DRAWINGS AMENDMENT ANNOTATIONS

REMARKS

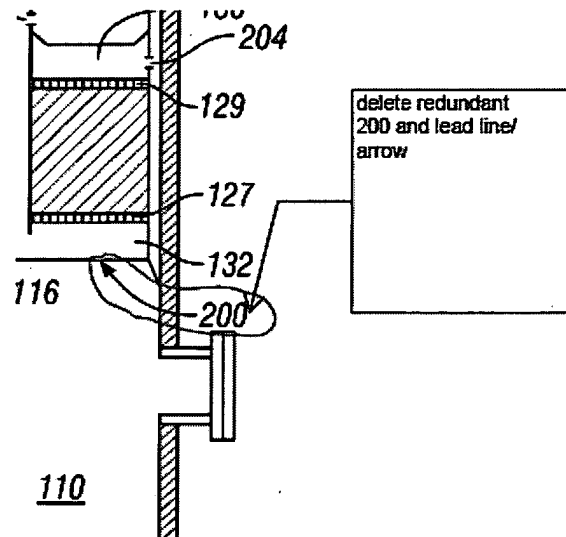
Replacement Sheet 2 is attached hereto in which Fig. 2 is amended to delete one of the redundant 200 reference numerals as shown in the following cropped markup:

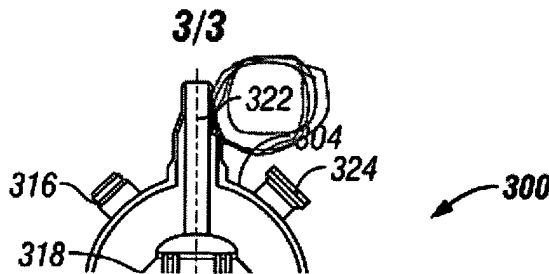
Fig. 2 is amended to remove one of the redundant reference numeral 200's. The office action also objected to the drawings in that reference numeral 322 mentioned at paragraph 28 was said not to be found in the drawings. However, it appears the presence of the reference numeral in the upper central portion of Fig. 3 may have been overlooked as indicated in the following cropped portion of Fig. 3:

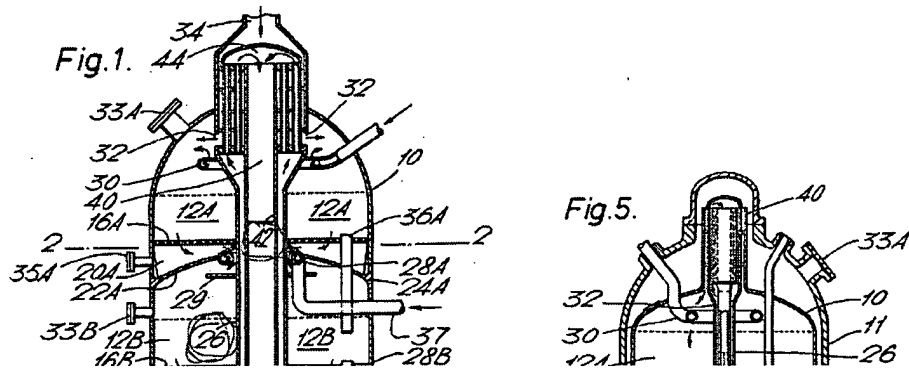
Moreover, the recitation in claim 6 of "a discharge passage in fluid communication between the upper and lower discharge plenums and a shell-side fluid inlet to the heat exchanger" is not met in *Notman* by alleged shell-side feed gas inlets 34, 30, 28A. In claim 6, the discharge plenums are connected by a passage to the shell side of the heat exchanger; in *Notman*, the discharge plenums feed into pipe 26, up to the tube-side of the exchanger 40 where they are cooled and thence to the final catalyst stage via central pipe 42. The tube-side *Notman* configuration of the pipes 26, 42 in a pertinent cropped portion of Fig. 5 is more easily seen by reference to the similar arrangement in the corresponding cropped portion of Fig. 1:
